Planning Applications Committee

Title	PLANNING APPLICATION UPDATE REPORT
Ward	Abbey
Planning Application Reference:	PL/26/0415 – Application for Approval of Reserved Matters
Site Address:	Station Hill, Reading, RG1 1NF
Proposed Development	Reserved Matters application pursuant to Outline Planning Permission ref. 192032 for the development of Plots A, B and D at Station Hill, Reading, comprising the erection of two buildings to provide residential units (Use Class C3), including affordable housing, ground floor flexible commercial units (Use Class E), resident amenity space, associated landscaping and public realm works, including Station Hill Gardens and to Station Hill Square, new pedestrian routes, cycle parking, servicing, refuse storage, plant and ancillary infrastructure, with all associated works. Discharge of conditions which are triggered with the Reserved Matters Application including Conditions 54(iii), 63, 75, 76, 86, 94, 95, 96, 99, 107 and 112.

APPENDIX 2 – Further Highway Authority Comments – In Full

Transport Comments

Image 1 – Landscape areas along Greyfriars Road

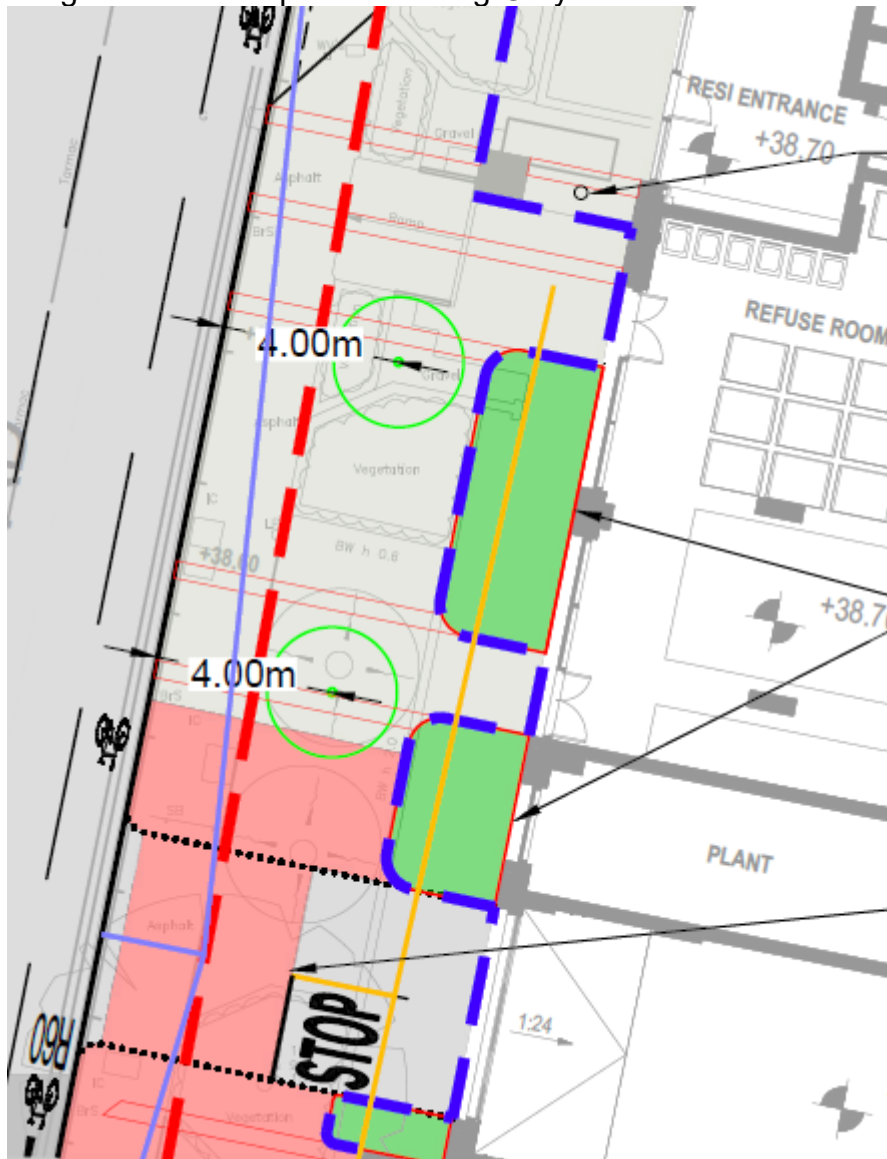
To compensate for the cycle visibility along Greyfriars Road the applicant has proposed a series of 2.7m deep landscaped areas as is illustrated in image 1 below. However, these oversized landscaped areas will create an environment that would be difficult to navigate for those that are blind/partially sighted as they follow the building line. This poor arrangement has been proposed to cover up the cycle visibility concerns discussed later in this consultation response. The Highway Authority would request that this proposed landscape layout should be revised.

3.	<i>Cycle Visibility and Planting Beds – Greyfriars Road</i>	6.73, 6.74	The planting beds have been provided partly in response to earlier Highway Authority comments. New comments regarding the beds causing an obstruction for blind and partially-sighted persons are noted. It remains the case that a well-proportioned (generally 4m wide) footway would be provided west of the

colonnade columns and line of street trees which would provide the most legible and straightforward route for all users. Ultimately it is considered that an appropriate balance is struck between the need to provide a safe and unobstructed route, the need to introduce planting and other visual enhancements and the functional requirements of the buildings as designed. This is set out in the main report. Additional tactile paving or high-contrast paving/markings could be included in the future hard landscaping (see Condition 2) where appropriate.

Image 2 – Diagram illustrating desire line

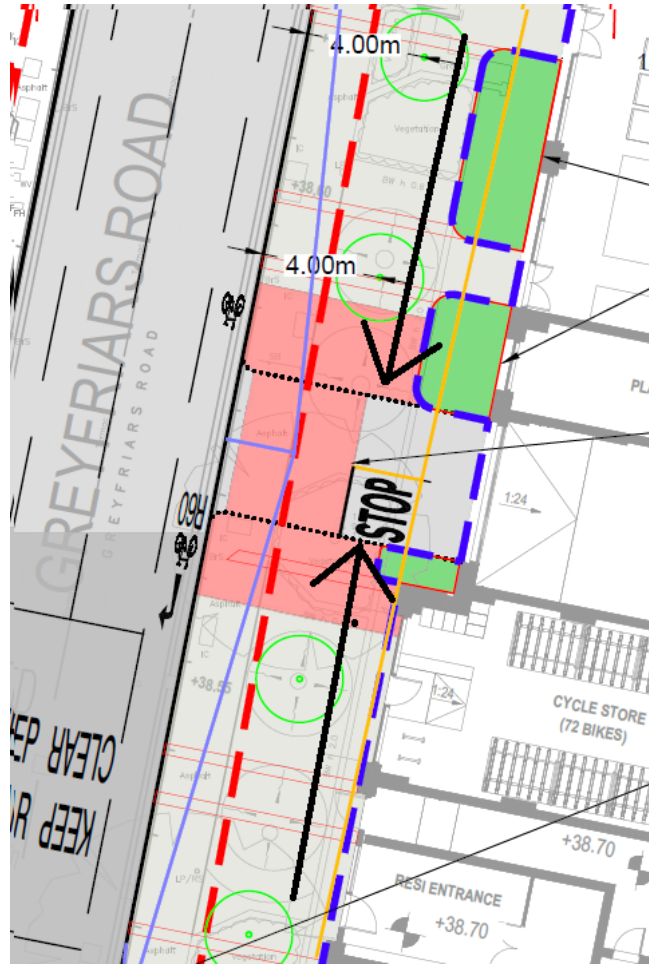
Visibility splays for the vehicle accesses have been illustrated and the Greyfriars Road splay is deemed acceptable. A cycle visibility splay has been illustrated at the access onto Greyfriars Road but the revised layout still illustrates the stop line along the desire line for pedestrians and cyclists. The applicant has stated that the landscaping around the access onto Greyfriars Road pushes cyclists away from building edge and the raised table now provides a desire line for pedestrians away from the stop line. In addition, the applicant has stated that the inclusion of the Sheffield stands to the south of the vehicle entrance will deter cyclists from cycling along the building edge. However, as Image 2 below illustrates by way of the black arrows there is still a desire line for pedestrians and cyclists right adjacent to the building line / landscaping especially as a cycle store, the Sheffield stands and residential entrances are located directly south of the vehicle access.

Image 2 – Diagram illustrating the required landscaping

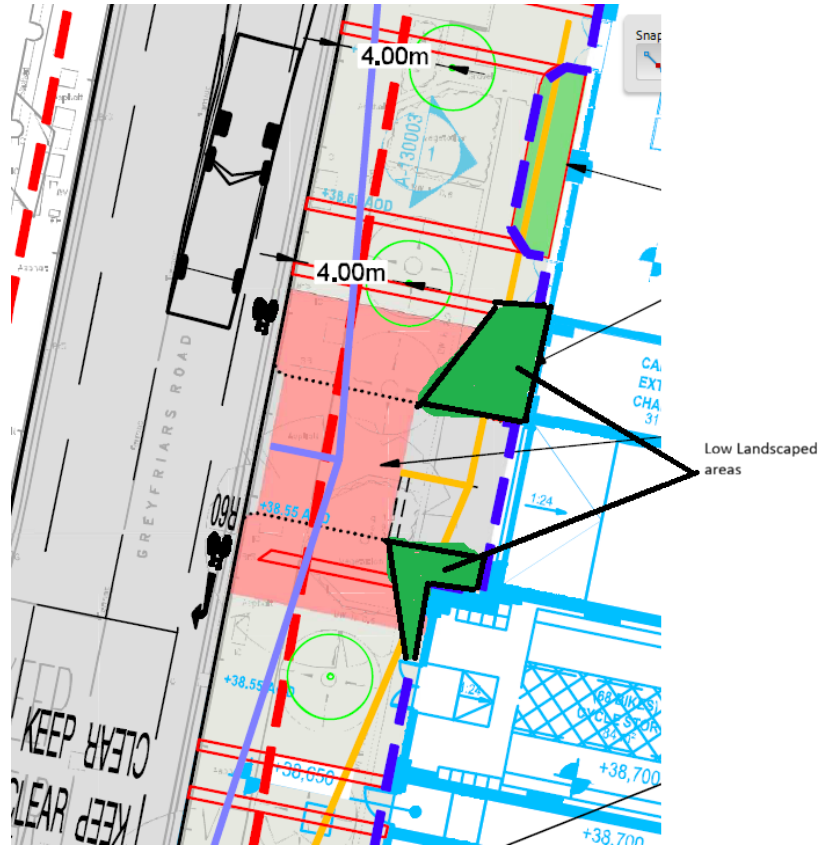
As had been previously discussed and agreed at the pre-application meeting some form of increased physical measure is required to effectively direct pedestrians and cyclists away from the building edge to ensure that adequate sightlines are provided. It had been agreed that low level landscaping would be provided similar to what has been proposed to the north but a larger area on both sides of the access but this has not been illustrated on the submitted plans. As previously advised a proposal similar to that provided at Image 3 below must be incorporated into the scheme design or the give way line would need to be set back into the site and the building line adjusted to facilitate the visibility splay. It is noted that this would need to be reviewed to take account of the revised stop line.

Notwithstanding the above comments I must advise that Image 2 above does now provide an acceptable visibility splay however the Highway Authority would still contest that will result in conflict between vehicles and pedestrian / cyclists and therefore is fundamentally unacceptable. This is a comprehensive redevelopment of the site and therefore there is no reason why a compromise in design standards would be necessary. The Highway Authority therefore fundamentally objects to the development given that it fails to provide an acceptable pedestrian and cycle route along Greyfriars Road contrary to National standards contained within LTN 1/20, the NPPF and the Reading Borough Local Plan.

4.	<i>Visibility Splays at Greyfriars Road entrance</i>	6.73	The request to further increase the extent of the planting beds and adjust the stop line is noted. This has already been addressed in the main report (para. 6.73). Further enlargement of planting beds would add further undesirable obstructions to the footway. It is also important to consider that the access would serve a very limited number of spaces – 2 disabled parking bays and a single space for service vehicles. The scope for any conflict is therefore also limited. The access is designed as a raised crossing with the footway/cycleway continuing at the same level and vehicles passing over the raised table. This provides a clear indication to the few drivers that do use the access that they must be alert to and give way to any pavement users and proceed with due care. This is considered to be an appropriate design response in this urban context.

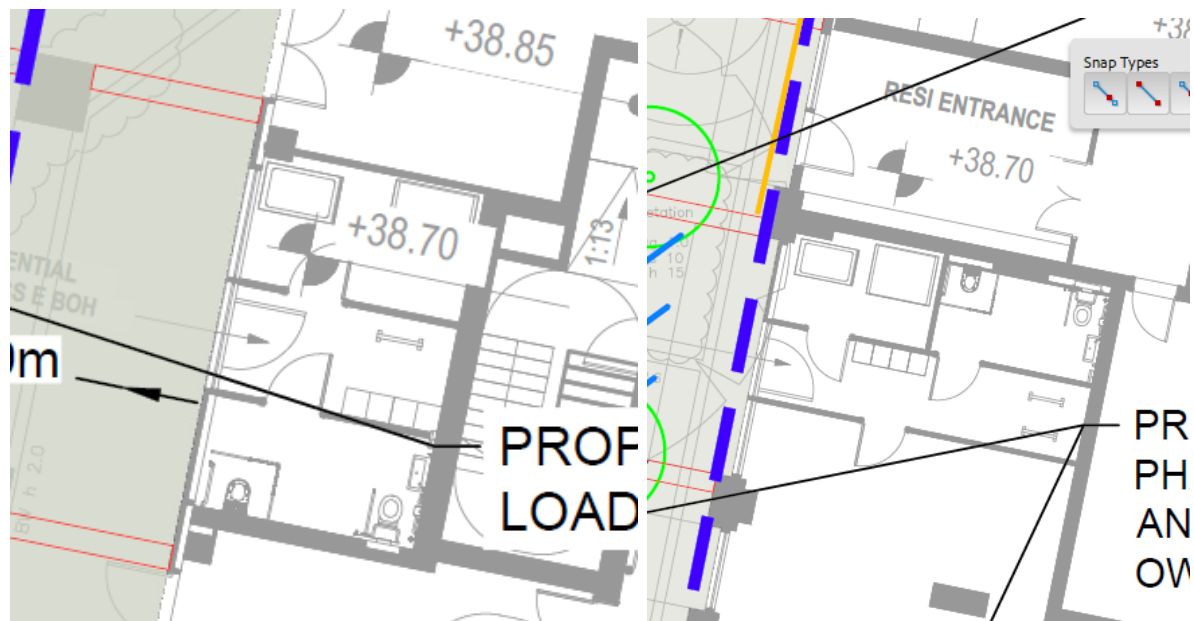
In the absence of established employee numbers, the RIC Employee Density Guide for A3 Restaurants of 1 employee per 15sqm has been applied by the applicant which is deemed acceptable. The commercial cycle parking requirements are as follows:

Across Plots A/B and D, a total of 11 staff cycle spaces and 4 visitor cycle spaces are required. The staff cycle parking storage will be provided internally within dedicated stores as part of the back of house facilities. These were illustrated within Figure 4.2 of the Transport Statement dated May 2026 but no updated plans were provided at that time. Updated plans have now identified that the cycle parking spaces do not comply with standards as they are not provided with 1m centres and are less than 0.55m from an adjacent wall. I have been unable to assess the cycle parking spaces for the unit at the podium level as updated plans have not been provided. Regardless the proposed arrangement fails to demonstrate an acceptable cycle parking layout for the commercial units. The Highway Authority would also still have concerns about the bins and cycles being accessed from the same area albeit there being a door in between (images below). It is highly unlikely that the bins are going to be relocated to the bin store area with them being left in the cycle store especially as the 1100l bin would be too large to get through the door of the refuse store. This will not help

encourage cycling as an alternative mode and therefore the Highway Authority would object to the proposed staff cycle parking layout.
